**Agenda Item 4**  
**1925 Field Court – City of Lake Forest Police Department Headquarters**  
**Addition to Office Building**

**1925 Field Court  
City of Lake Forest Police Department Headquarters**

**Consideration of a request for a recommendation in support of an addition to an existing office building to support adaptive reuse of the building as the City's new Police Department Headquarters.**

SITE PLAN WITH FOOTPRINT OF THE PROPOSED ADDITION

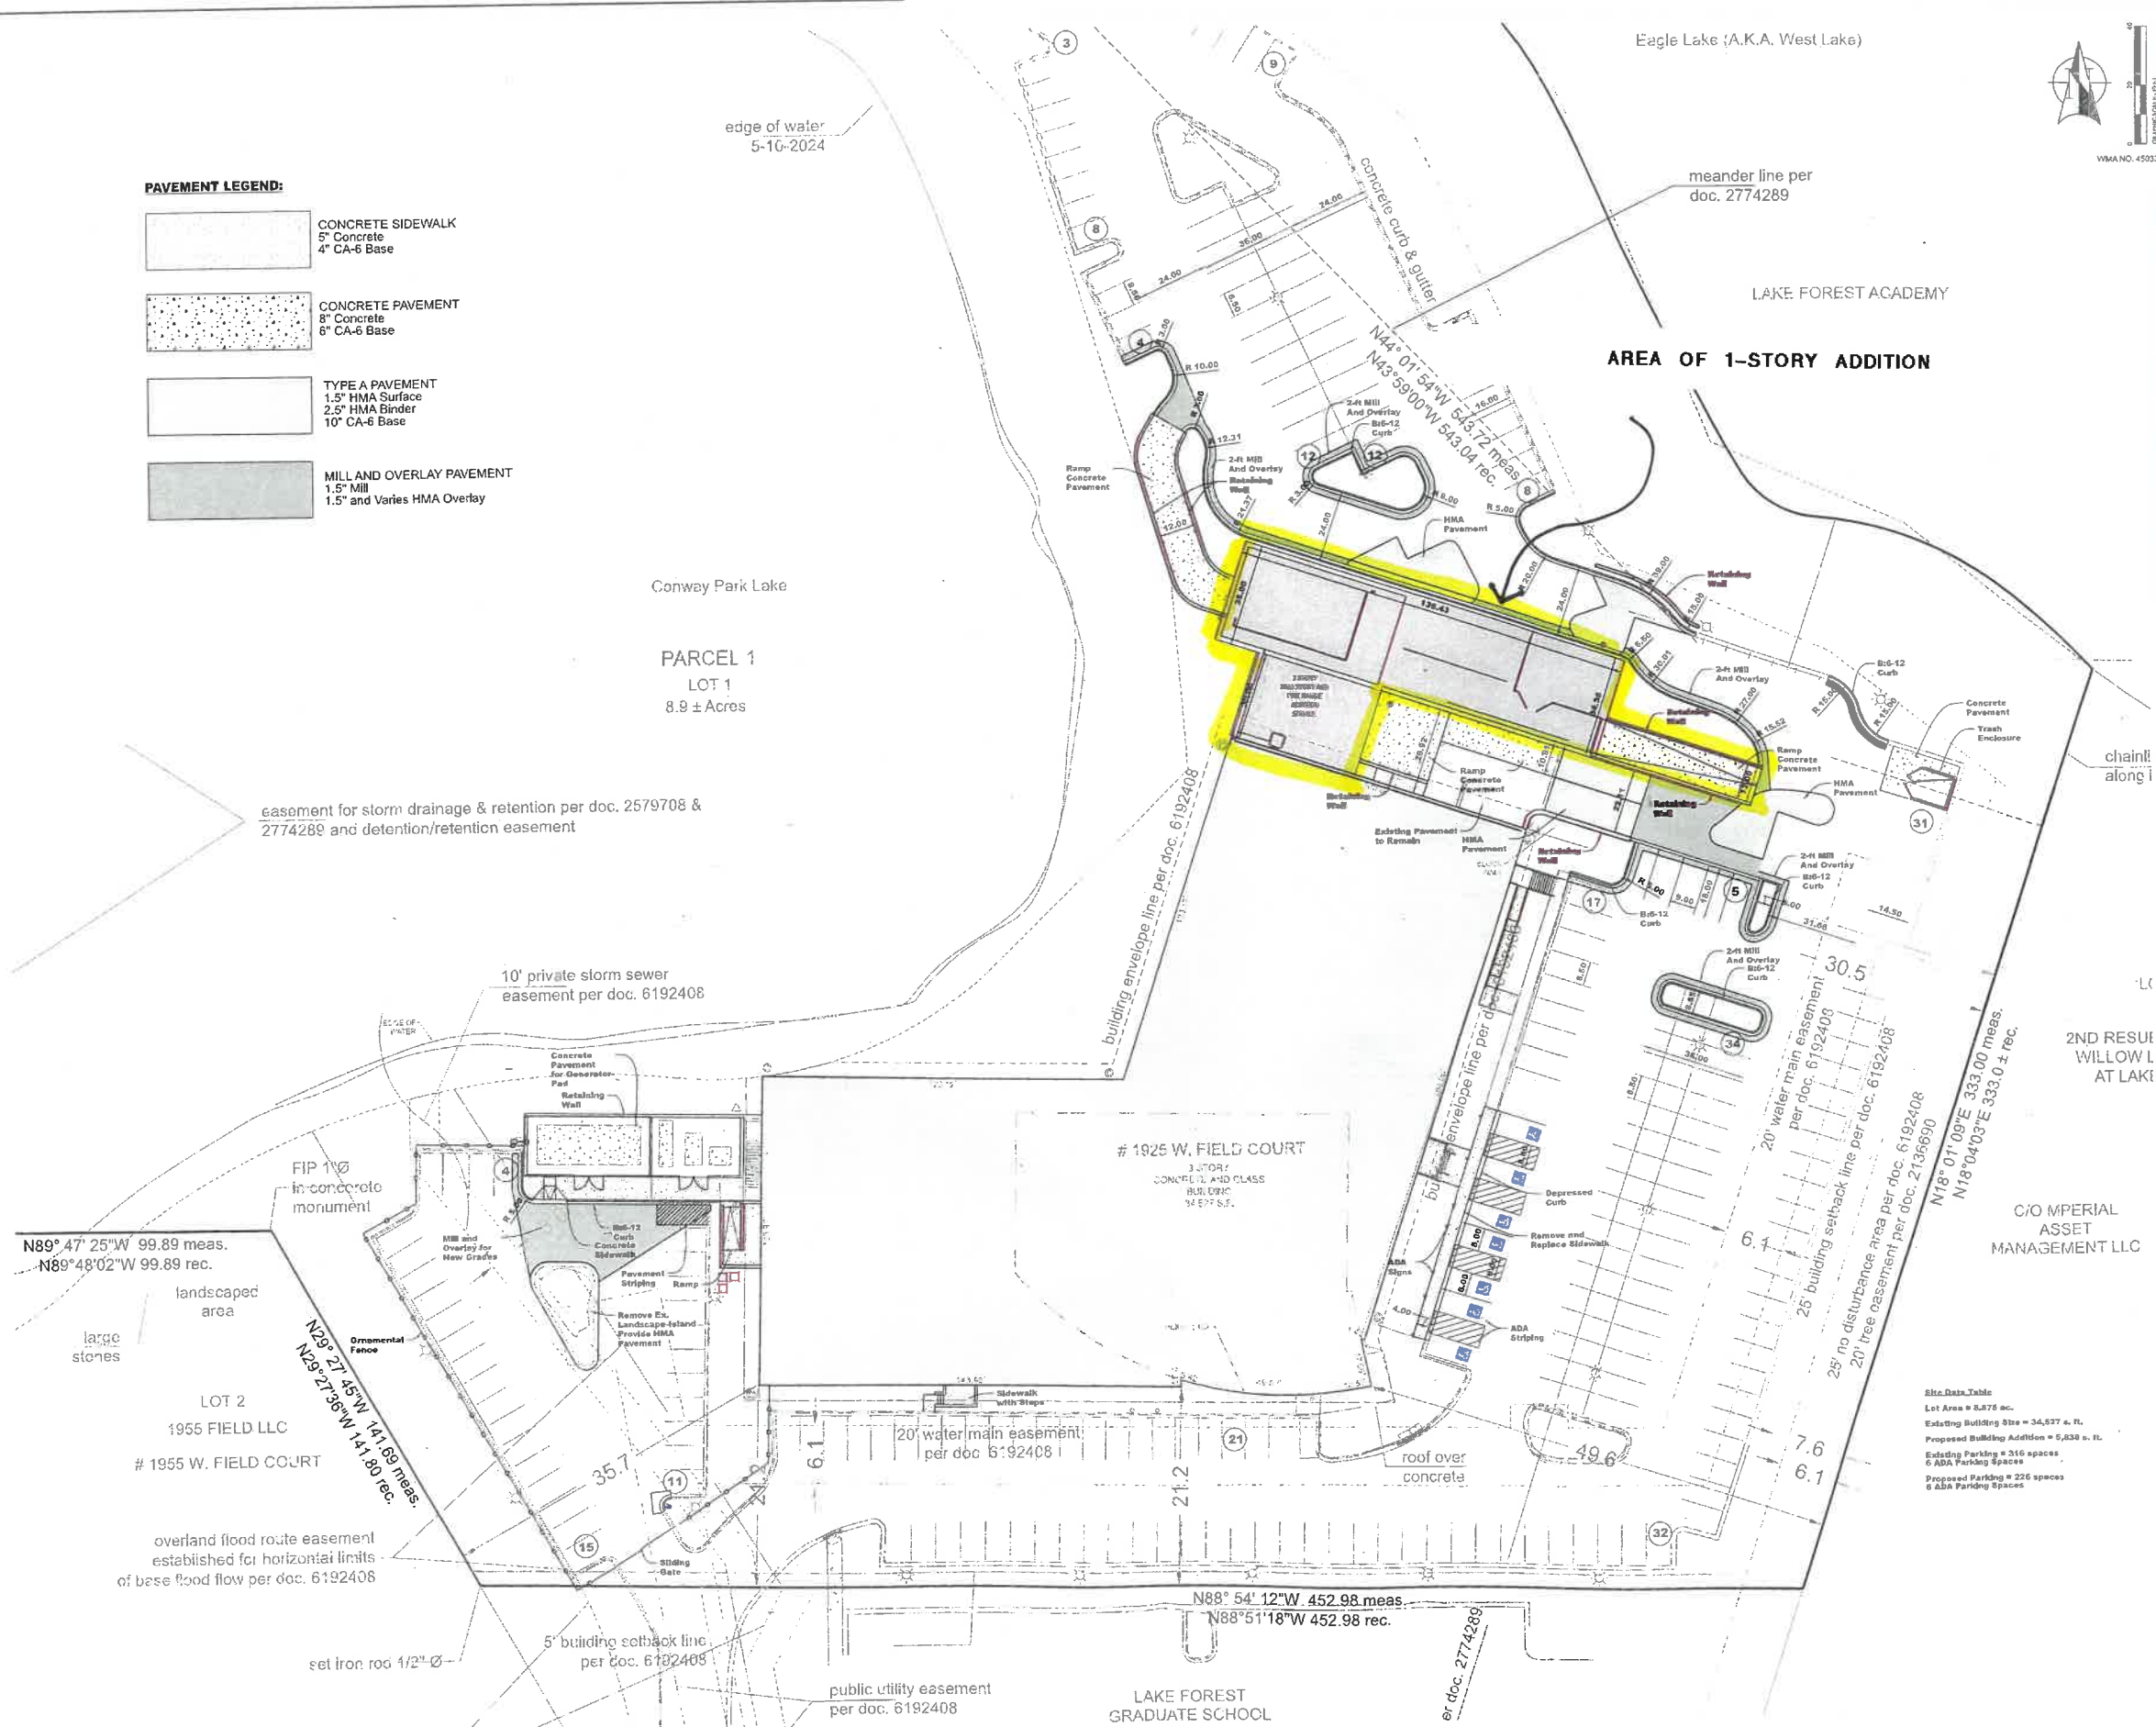
As reflected on the site plan included in the Board's packet, the proposed one story addition is located at the rear of the 1925 Field Court office building. The addition is located to the north and west of the existing ramp which provides access down to the parking garage located under the building. The grade change in this area makes it necessary to access the sally port garage by way of a ramp sloping up to the garage which will align directly with the level of the first floor of the building. As noted above, and as reflected on the site plan, a ramp extends down from the sally port to allow vehicles to pass through the structure.

The configuration of the existing parking lot will change slightly to accommodate the ramps and the addition.

The addition is located at the rear of the building, minimizing visibility from off of the site with the exception of perhaps some limited view from the office buildings on the west side of the detention pond. The siting of the addition takes advantage of the grade change and allows the firing range to be concealed to a great extent, with minimal height and visible mass.

# WEST ELEVATION

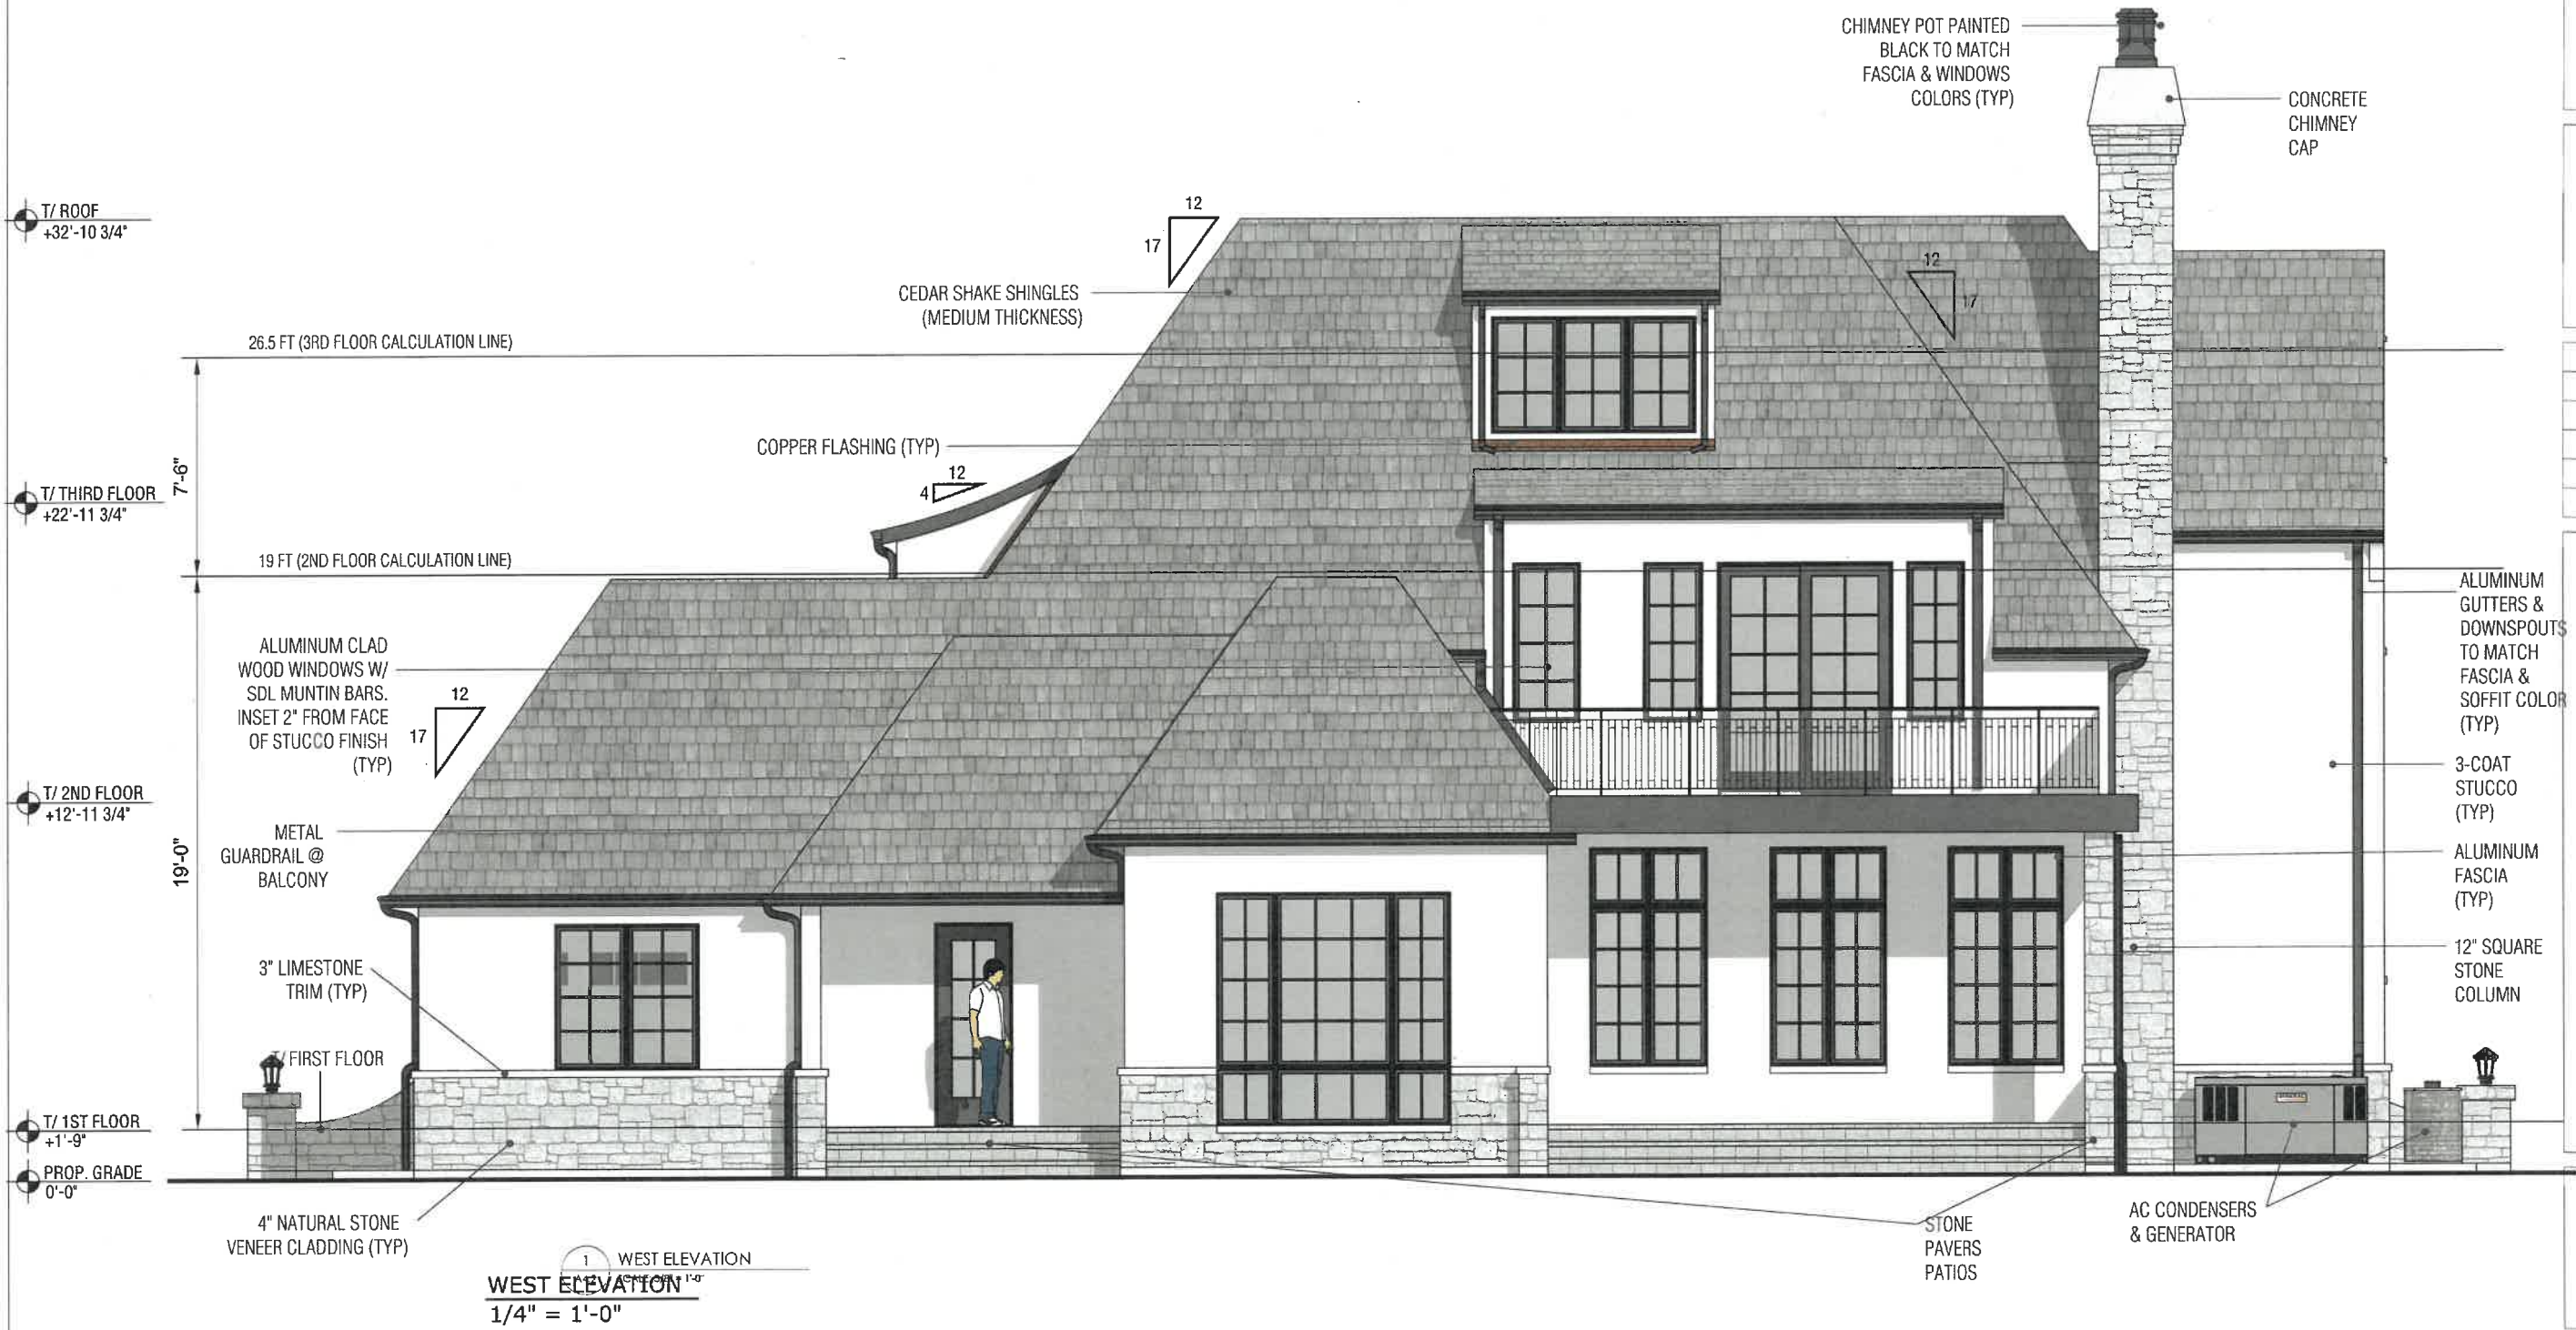
1. Prior to submitting plans for permit refine the plans as follows and provide the additional information requested.
  - a. Conduct further study and refinement of the massing and roof forms on the west elevation to simplify and better organize the massing.
